## HISTORIC AND DESIGN REVIEW COMMISSION

October 19, 2016 Agenda Item No: 11

**HDRC CASE NO:** 2016-411

**ADDRESS:** 815 S ST MARYS

Alamo City Cryotherapy Window Depth

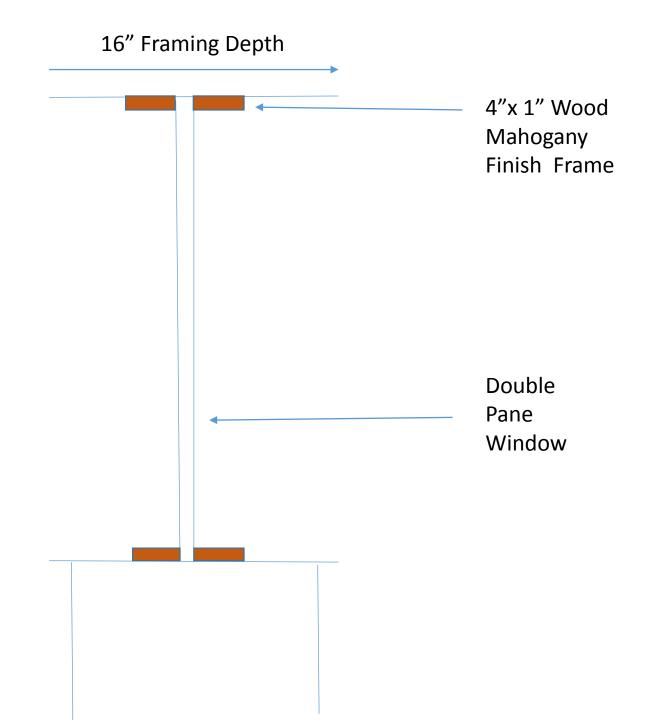
- a. The structure at 801/803/809/815 S St Mary's, also known as the King William Professional Building was constructed circa 1940, underwent façade alterations circa 1970 and is located at the corner of S St Mary's and Madison in the King William Historic District.
- b. The applicant has proposed to install one 5'x5' window in the St Mary's (east facing) façade of the structure at 815 S St Mary's. Previous window installations have been proposed and approved by the HDRC on this façade. The applicant has noted that the proposed window will feature materials and a profile that matches the existing windows. Staff finds this appropriate and recommends that the proposed window features a sill height that is consistent with all existing windows on the S St Mary's elevation.

Staff recommends approval based on findings a and b with the stipulation that the proposed window feature a profile, setback and materials that match the existing windows.
